# CITY OF ALBUQUERQUE

**RE: 8500 Glendale Ave. NE**  
**Grading and Drainage Plan**  
**Engineer's Stamp Date: 05/28/19**  
**Hydrology File: B20D067**

## DRAINAGE AND TRANSPORTATION INFORMATION SHEET (REV 11/2018)

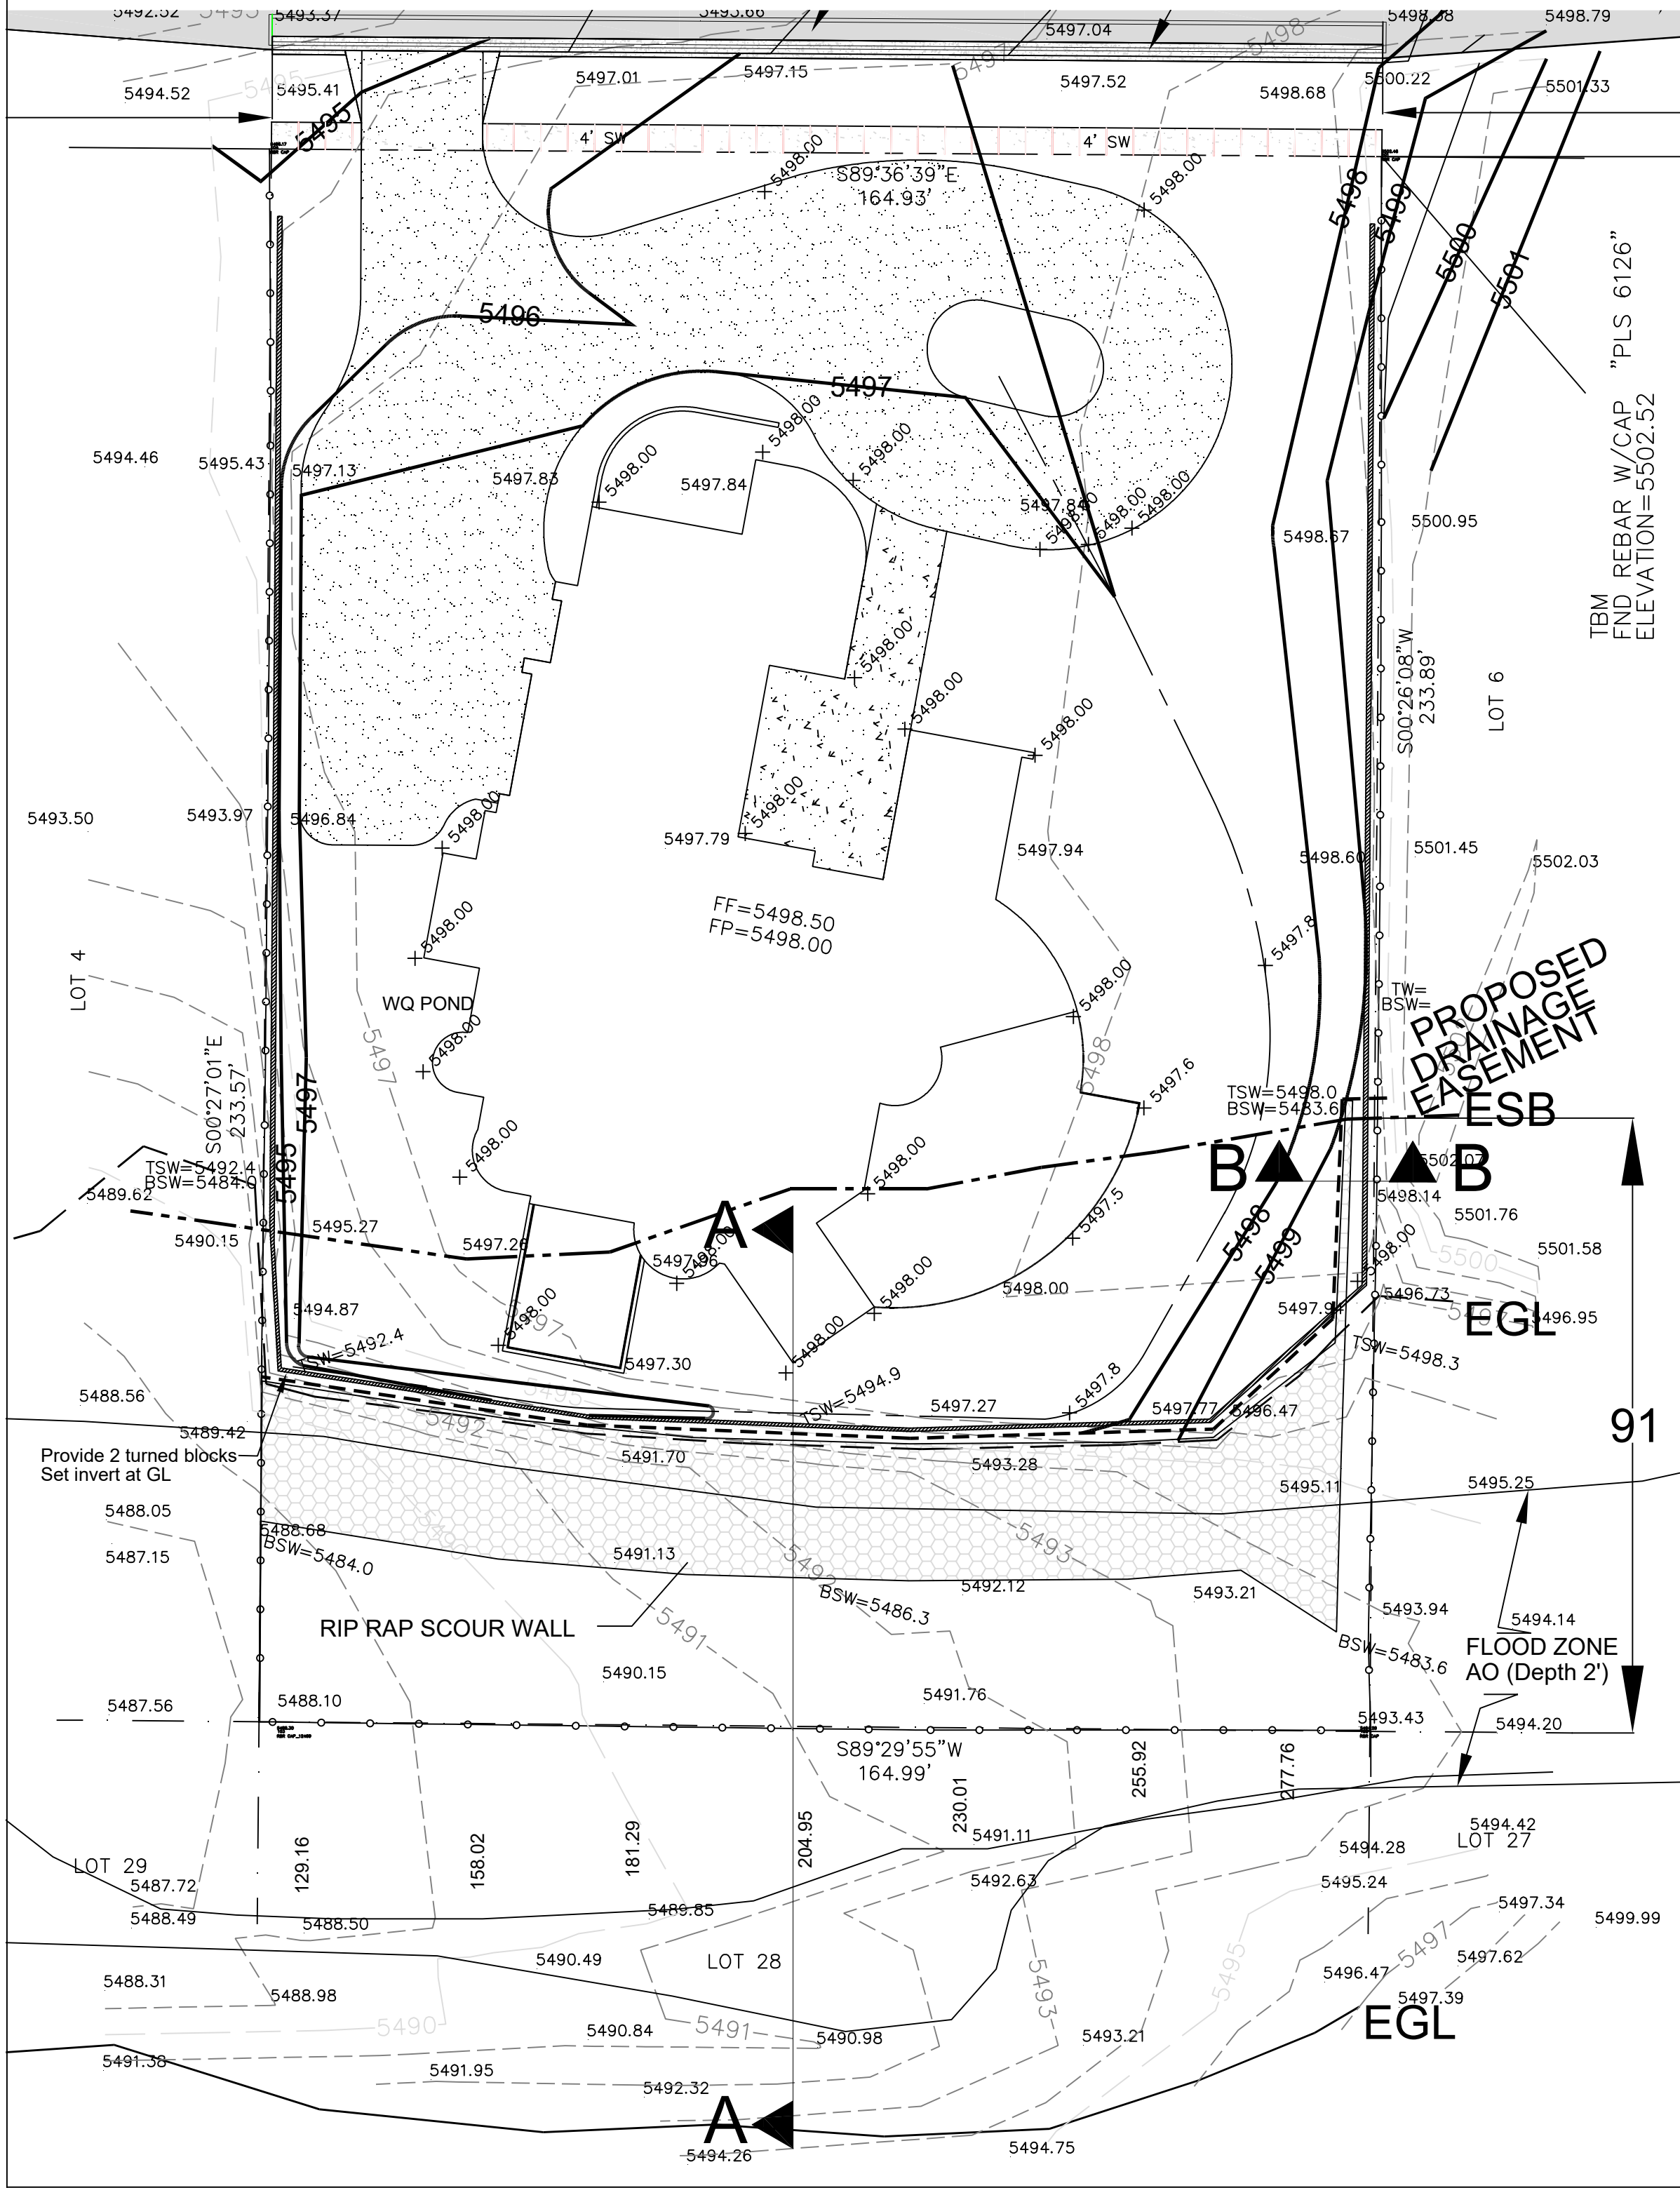
15. Please provide section of the riprap with all required dimensions. See image below. Also please call out the riprap type per City of Albuquerque Specification Section 109 (Riprap Stone). Please use the thickness of 1.2 ft as stated in your calculations. *Cross Section A-A has been updated with this information.*

505-249-4843 donbriggseengineering@gmail.com 5324 Oakledge Ct. NW, Albuquerque, NM 87120	
TITLE: 8500 Glendale Grading & Drainage Plan			
Design Review Committee	City Engineer Approval	Last Design Update	Mo. / Day / Yr.
City Project No.	Zone Map No.	Sheet	Of
B20D067		1	3

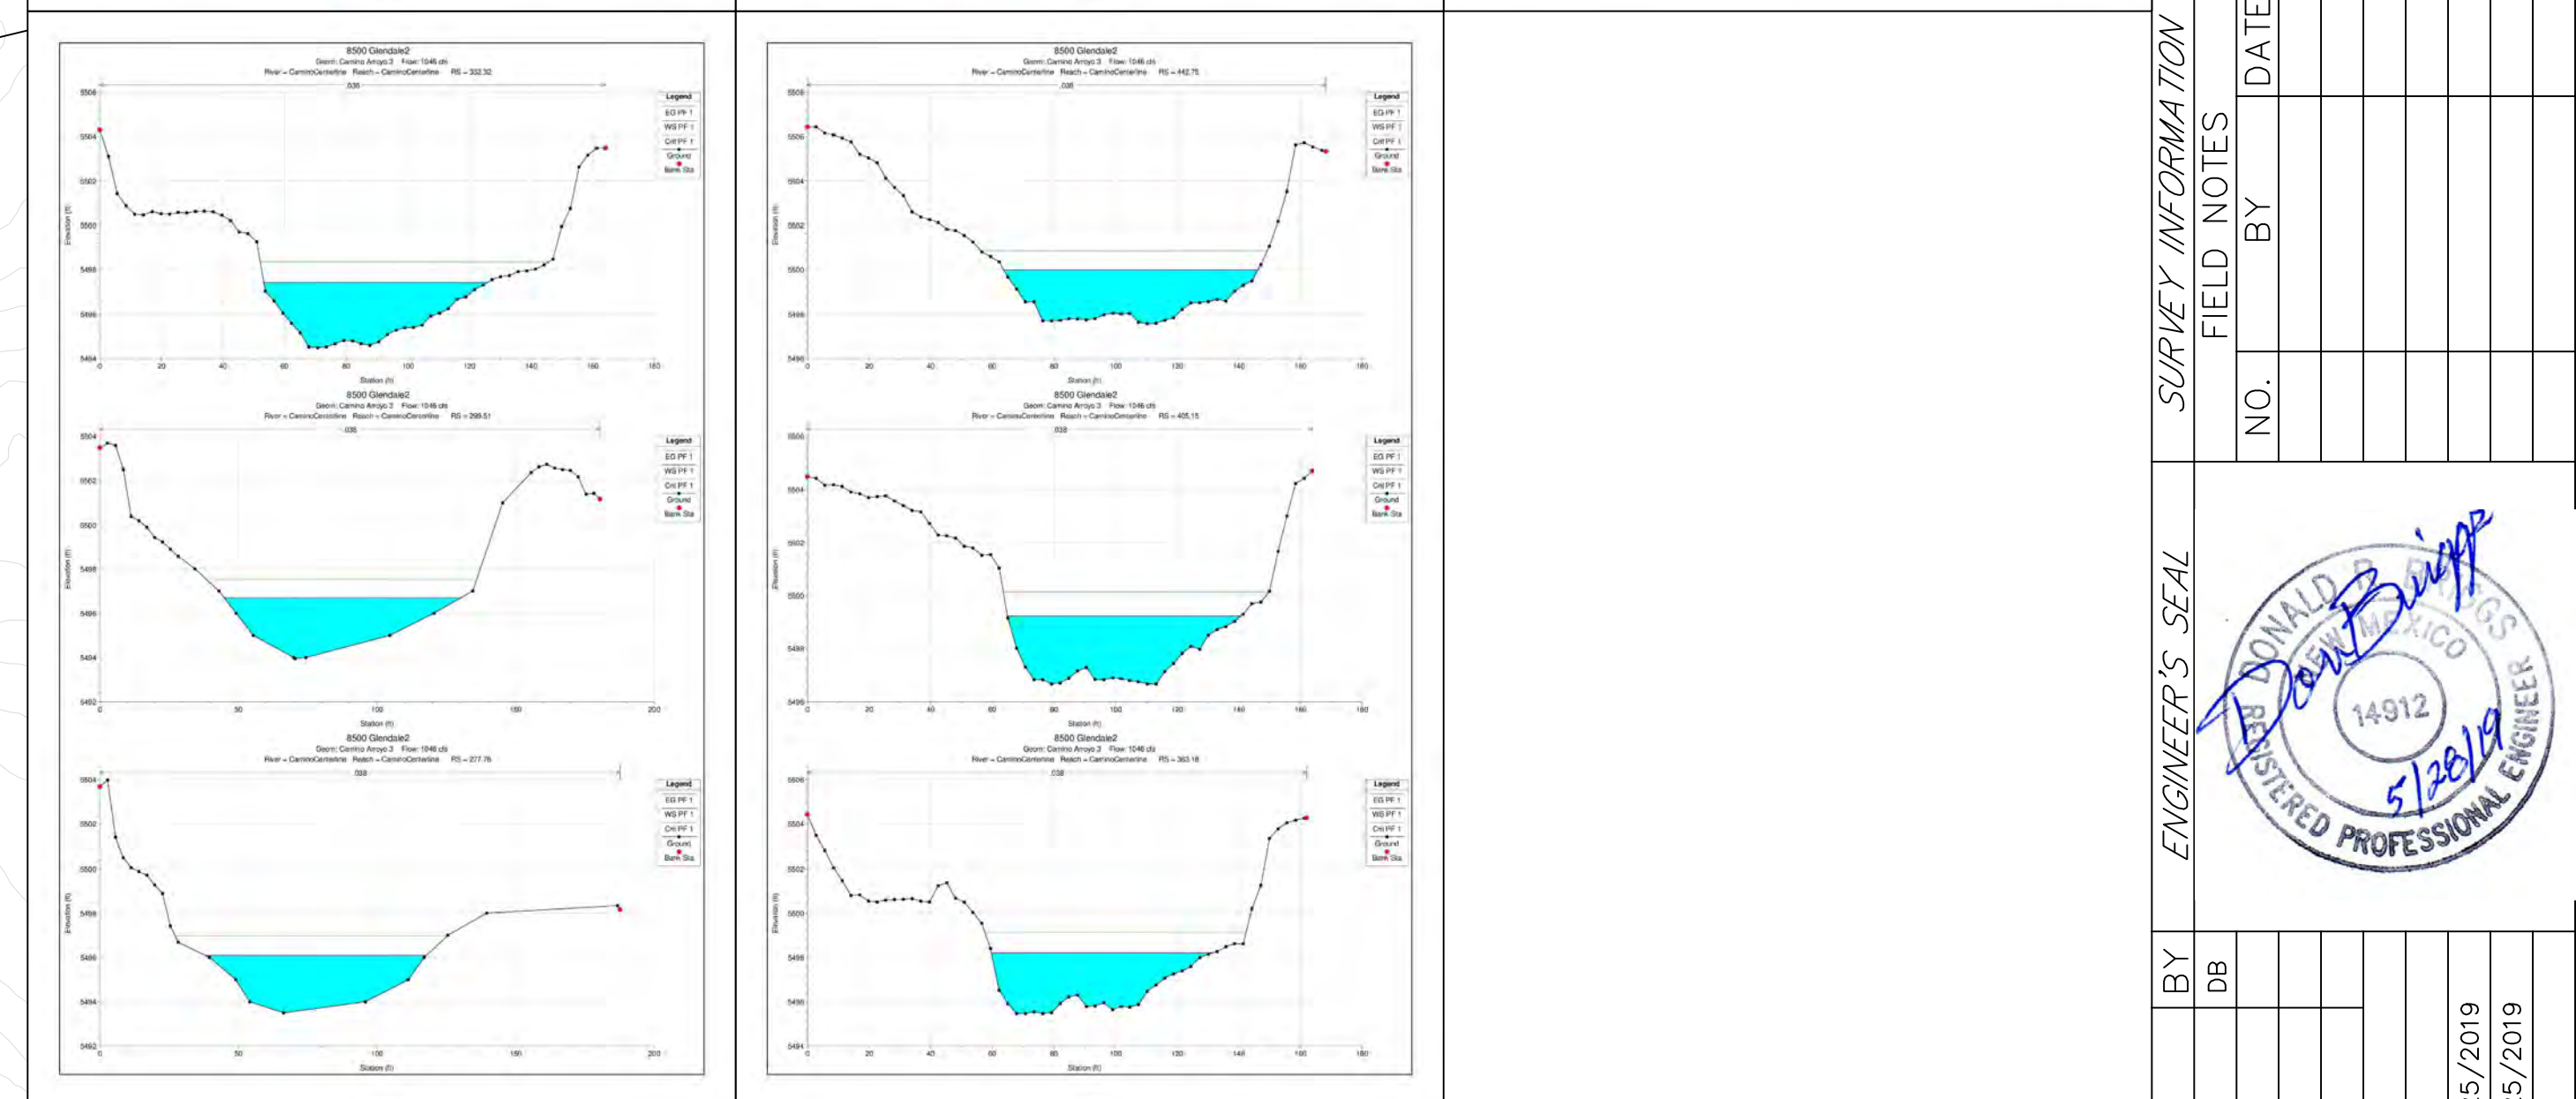
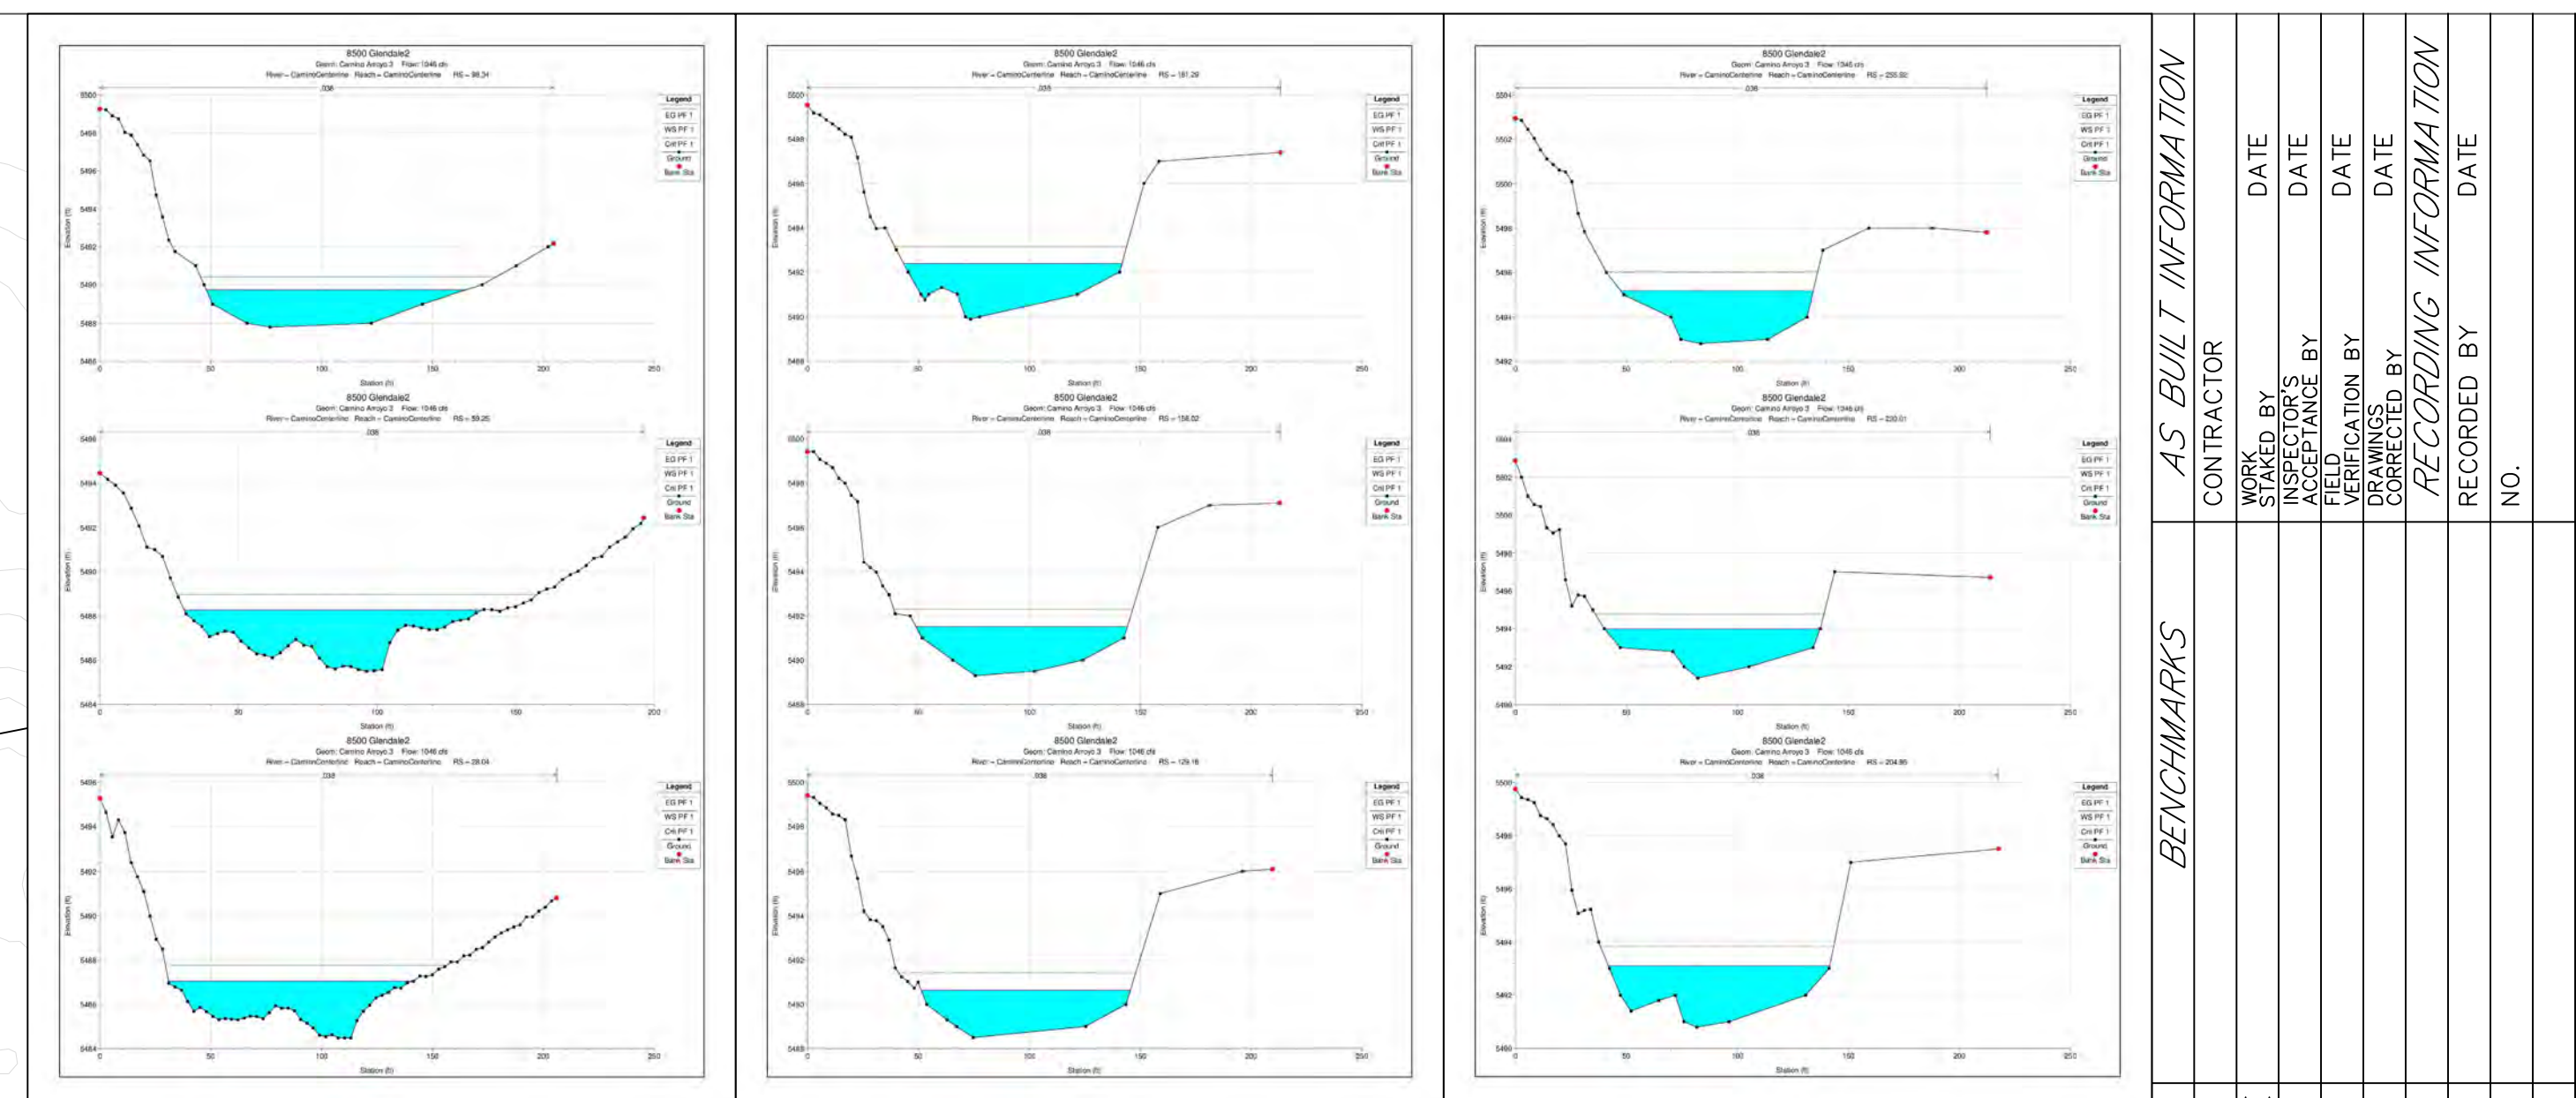
2. At the northwest and northeast corners of the property, there are proposed grading on the adjacent properties. Written approvals from both of the adjacent property owners are required prior to Building Permit approval.

12. Please provide a detail section of the scour wall along the East property lines. This section should include the distance of the proposed wall to the property line and should match the depth requirements from the calculations of 9.15 ft scour depth. This scour wall needs to extend to the southern edge of the riprap. *This has been added to the plan.*

14. The western edge of the riprap needs to be thickened to prevent erosion. Please add a note. *Note has been added to the profile.*

16. Please provide a profile of the riprap along the channel with the average slope, top elevation, bottom elevation, and toe elevation of the channel. *Profile has been provided.*

18. For the Proposed Drainage Easement shown, please removed the easement line along the western property line. The easement can stop at the property line. The easement along the eastern property line needs to be along the west side of the scour wall to the ESB line and then to the property line. *Easement has been revised.*
